## ADDENDUM NO. 2

**Date:** August 26, 2021  
**Project Name:** Airfield Marking Rehabilitation for the Jack Brooks Regional Airport  
**Owner:** Jefferson County, Texas  
**Owner Project No.:** IFB 21-052/JW  
**Garver Project No.** 20A12502

RUNWAY 16-34  
 MARKING REMOVAL  
 PLAN I

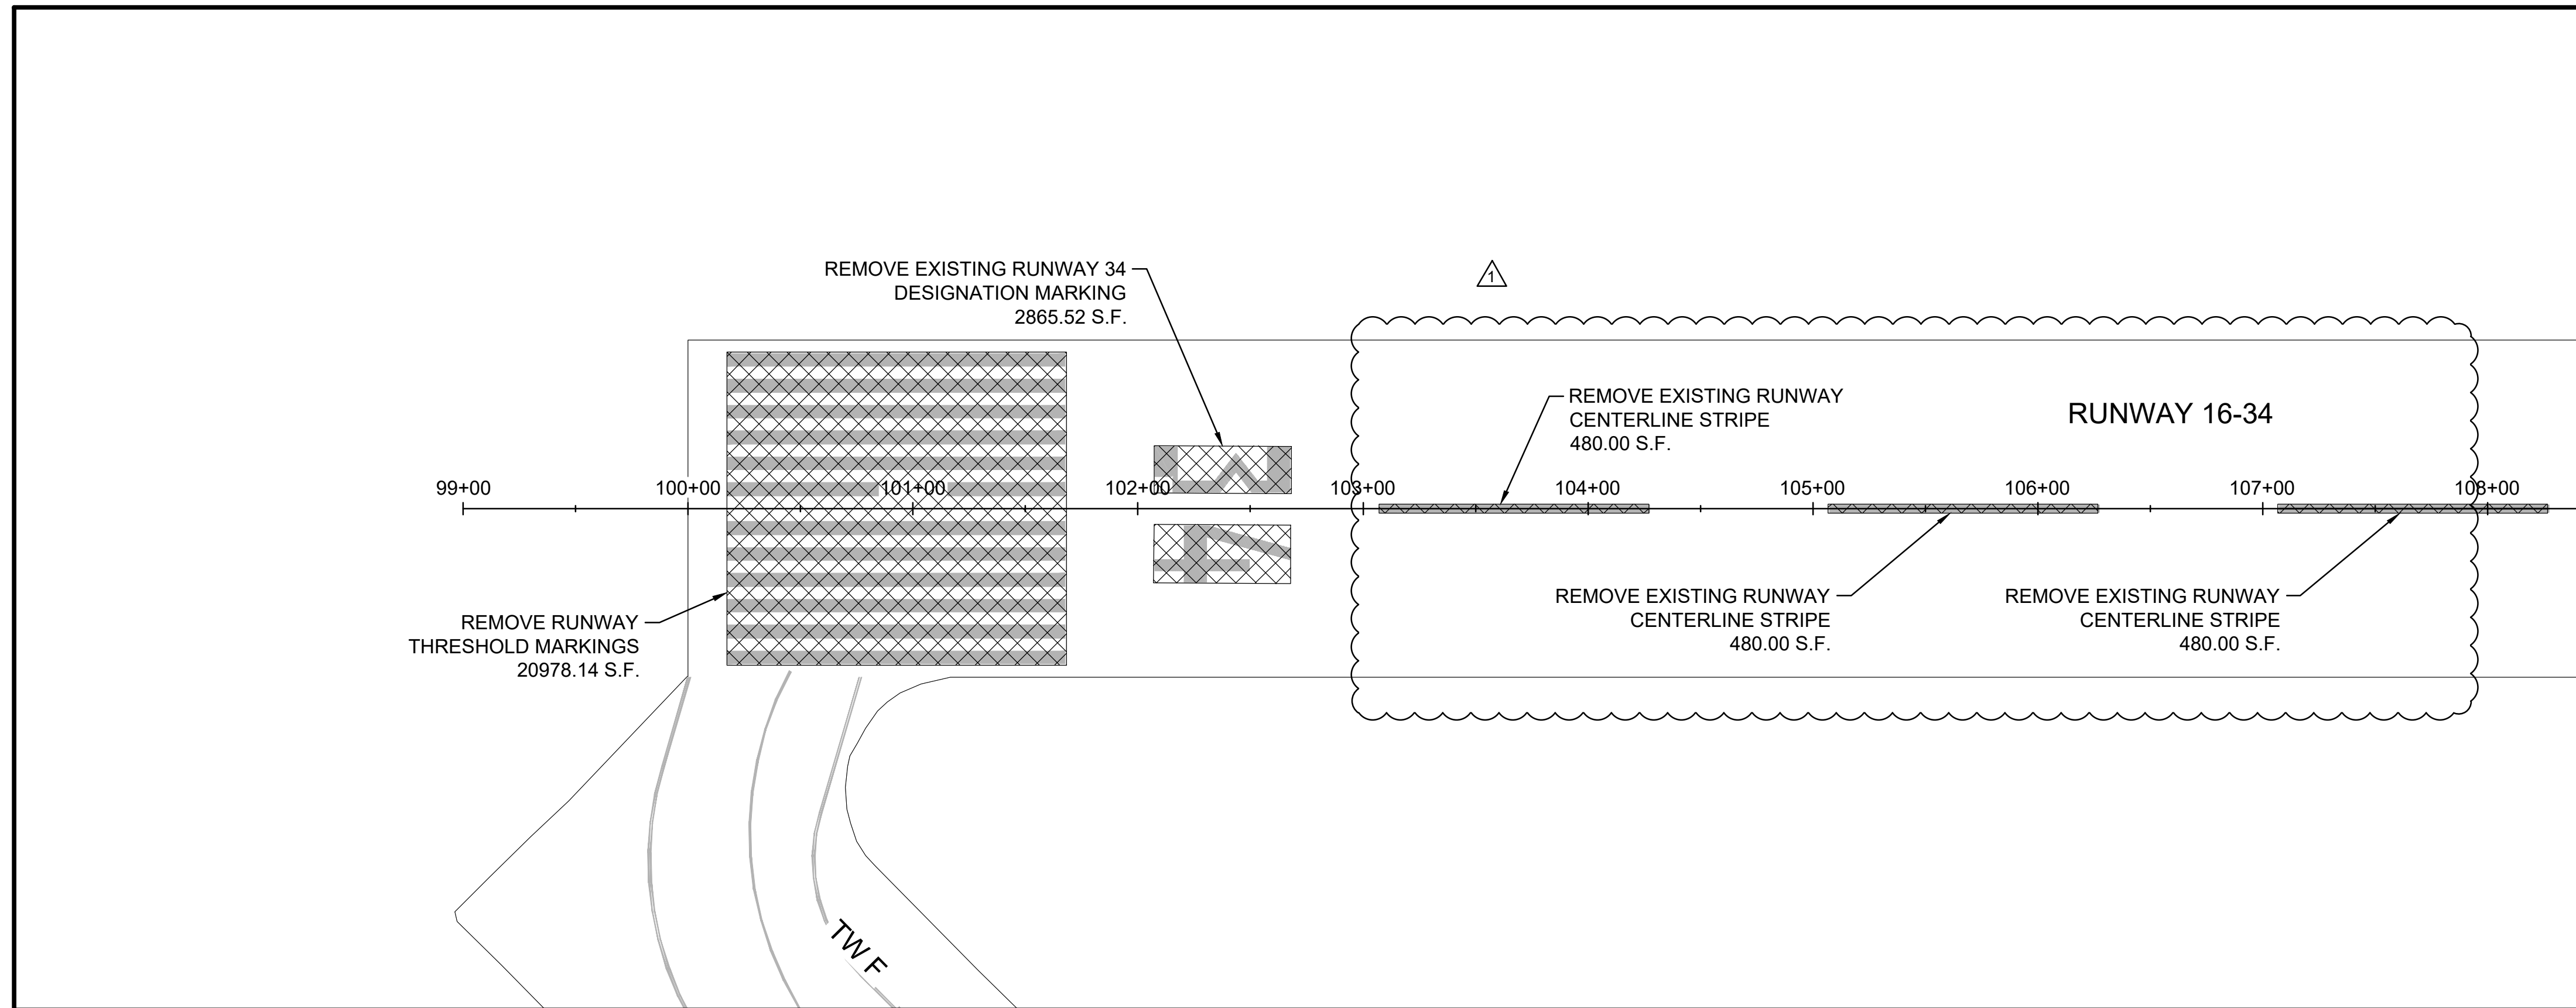
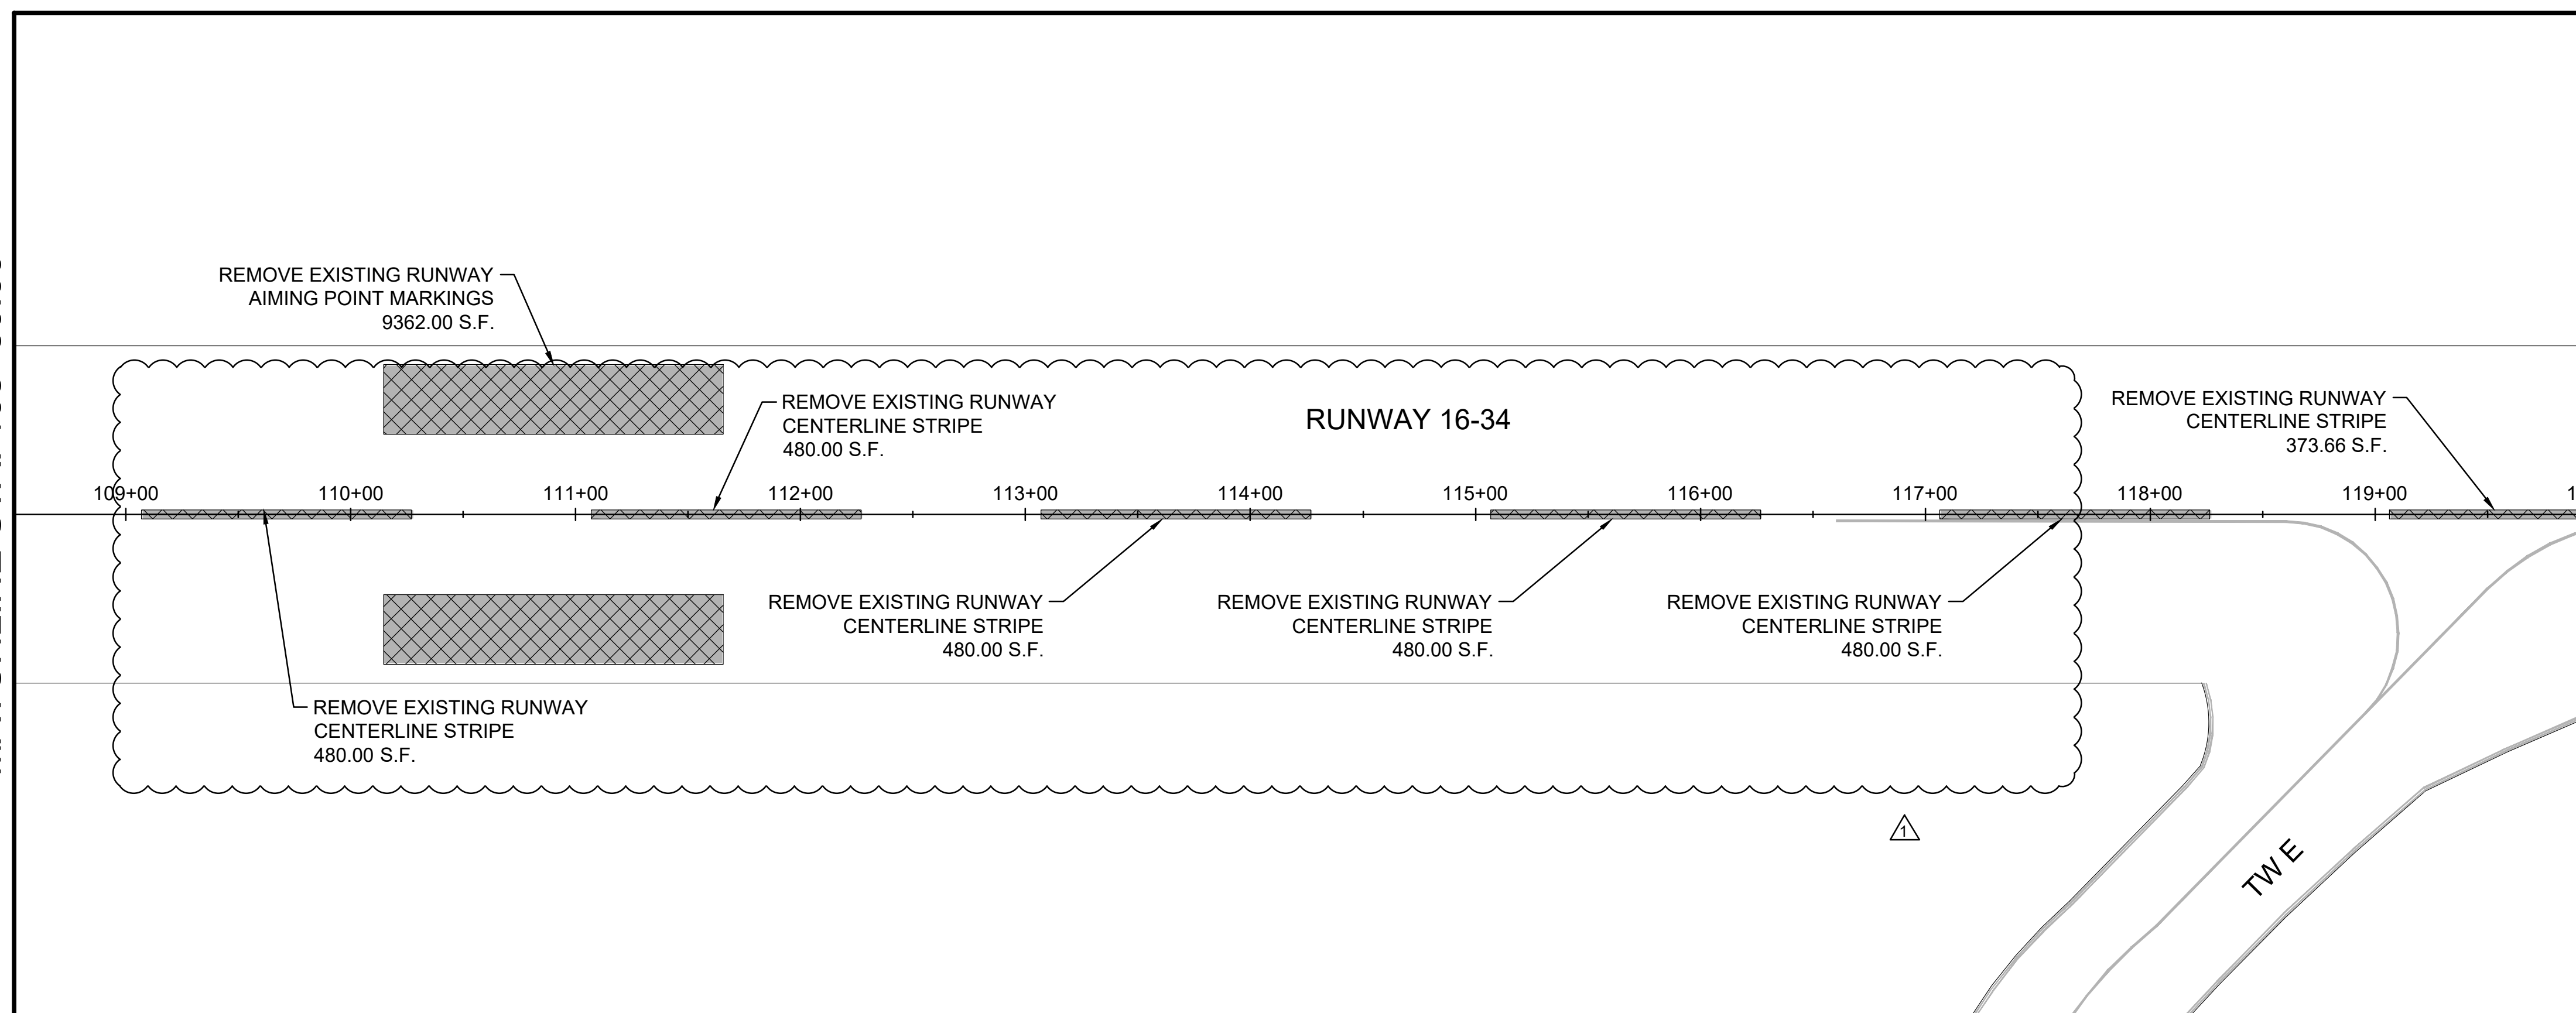
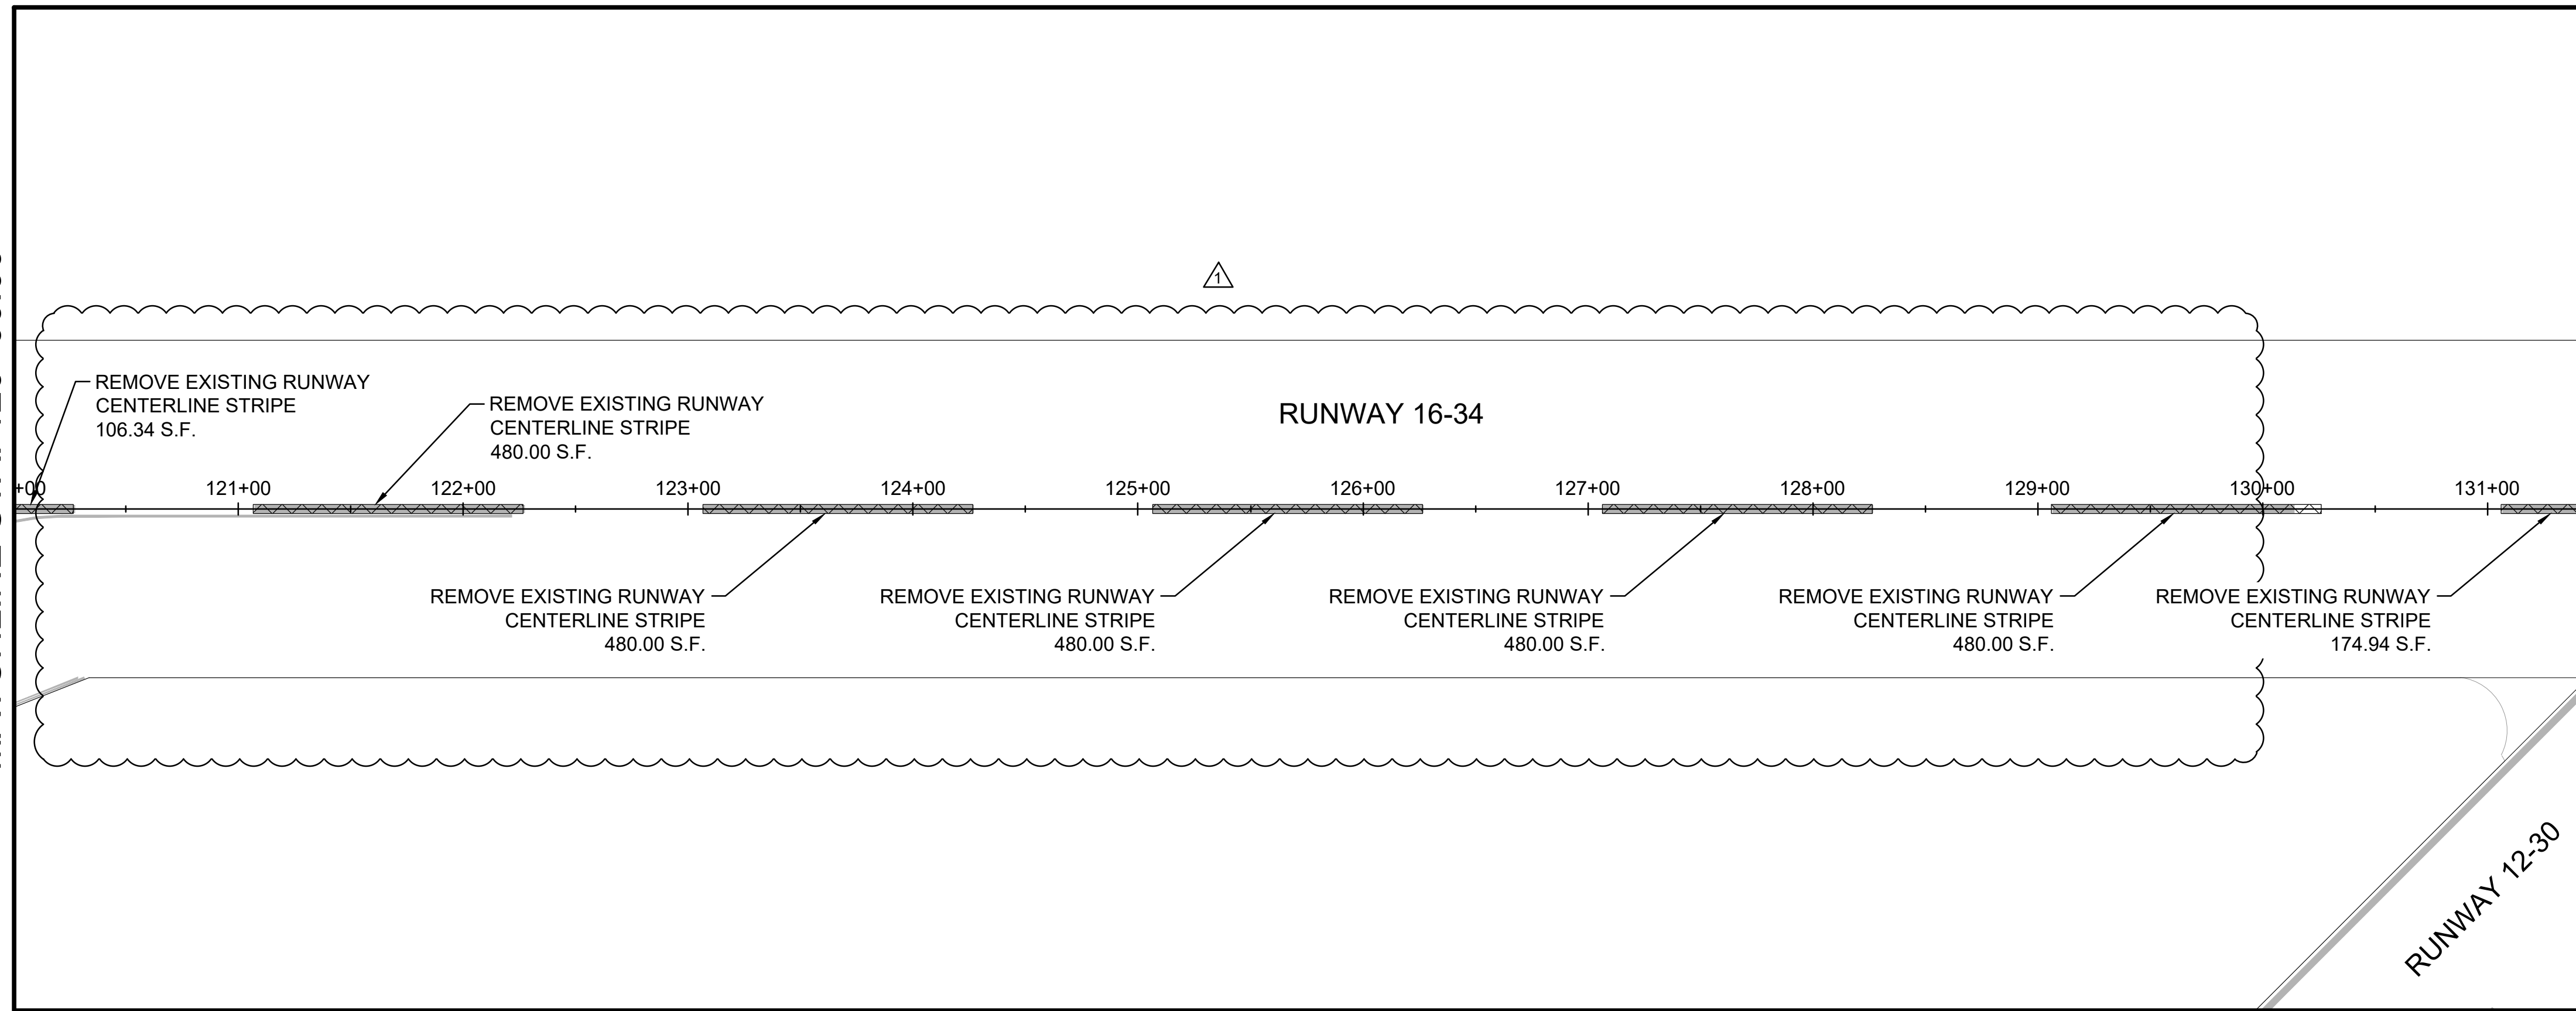
- f. According to Google Earth, the runway centerlines are 120 ft by 3ft for the white. On the plan sheets it says 120 ft by 18". What are the current centerlines measured at?

- g. How did you determine the square feet measurement of 433.55 on the centerlines? What measurements did you use?
  - i. The removal quantity for the existing runway centerline markings has been corrected (see section B below) to 480 SF in this addendum. This accounts for the 120 ft by 3 ft of white markings with the 0.5 ft black outline.

- h. How did you determine the square feet measurement of 9359.52 on the aiming point? What measurements did you use?
  - i. The removal quantity for the existing aiming point markings has been corrected (see section B below) to 9362 SF in this addendum. This accounts for the 150 ft by 31 ft of white markings with the 0.5 ft black outline for the pair of markings.

- i. The existing runway centerlines are 120 ft by 3 ft. The proposed runway centerlines will be 120 ft by 1.5 ft white paint with 0.5 ft black outline. The removal quantity for the existing markings has been updated (see section B below) in this addendum.
